REQUEST FOR PROPOSAL "ITT" No. PS20190830  
CONTRACTOR FOR RENOVATION OF TROUT LAKE PRESCHOOL

AMENDMENT No. 2

QUESTIONS AND ANSWERS NO. 2

ADDENDUM No. 1

Project: 18066  
**Trout Lake Community Centre Childcare**  
 Drawing Title:  
**Wall Diagram**

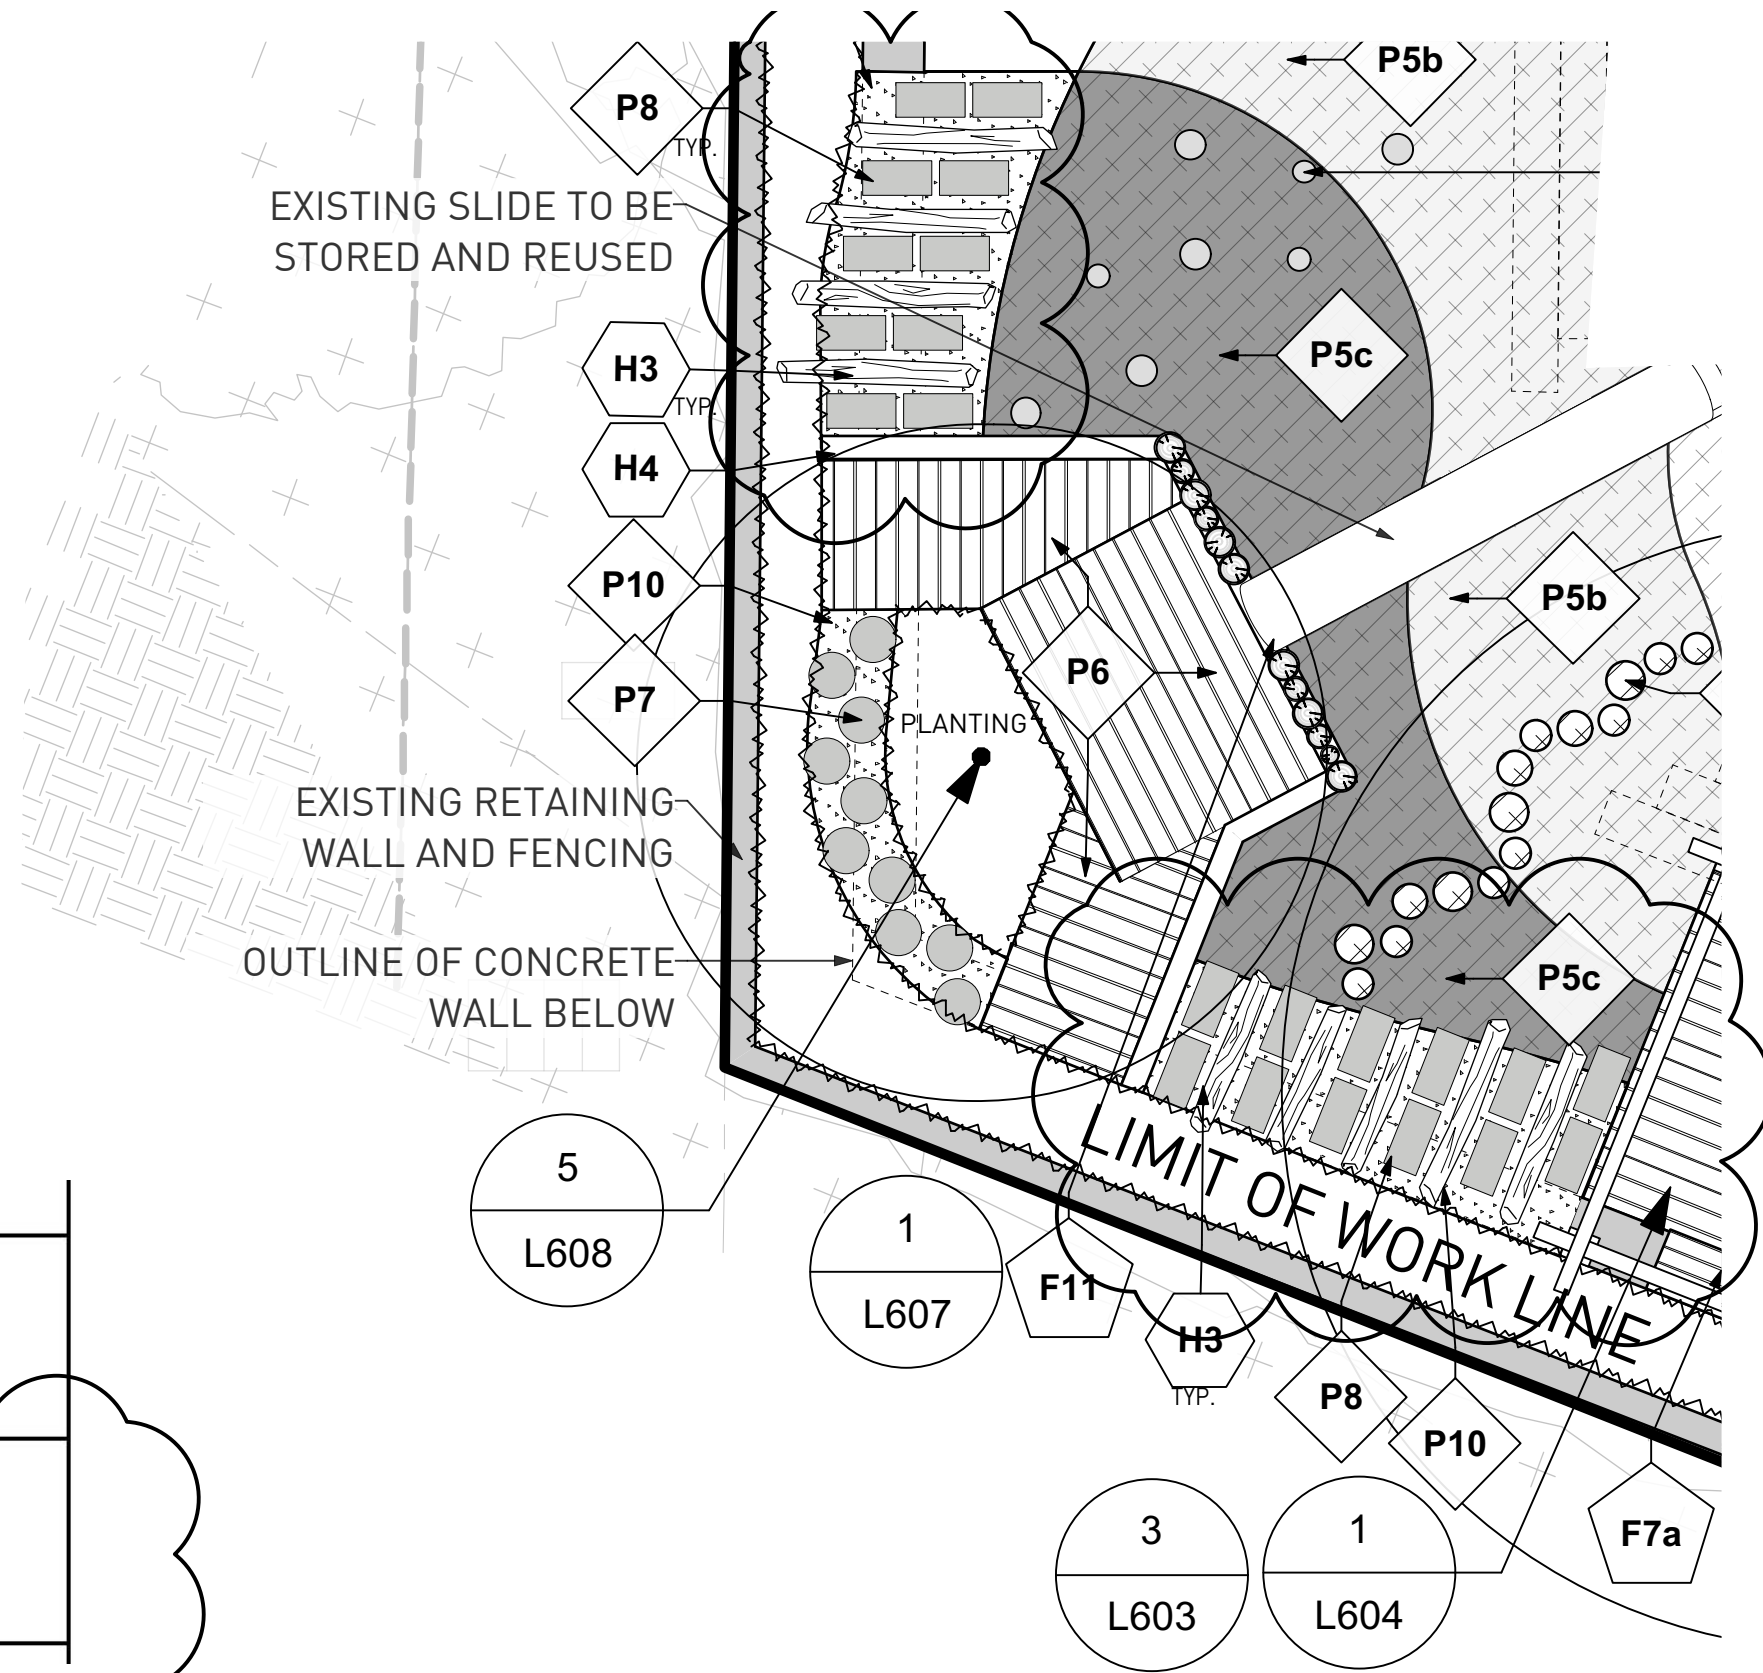
Q1	Are you able to provide existing grades other than the perimeter walls?
A1	<b>Please see CAD file for detailed survey of the site.</b>
Q2	Are you able to provide a detailed layout for concrete curbs, walls, footings?
A2	<b>Please see LSK02 for location and types of wall and footings keyed to detail numbers. More detailed layout or a CAD file will be provided at IFC.</b>
Q3	RE: the Type 2 pavers spec'd on the landscape drawings for the Preschool. Abbotsford concrete no longer manufactures 18" x 9" or 9" x 9" pavers. Do you have an alternative?
A3	<b>Please replace Paving Stones Type 2 (P8) with CCI Century Pavers Patio 2"x8"x16". Layout as per LSK01</b>

- 205mm DIA CONCRETE FOOTING 1  
L606
- 205mm DIA CONCRETE FOOTING 2  
L607
- 230mm WIDE CONCRETE WALL WITH 660mm CONCRETE FOOTING 2  
L603
- 400mm WIDE CONCRETE WALL 3  
L602
- 150mm WIDE CONCRETE CURB 1  
L607
- EXISTING CONCRETE WALLS AND CURBS
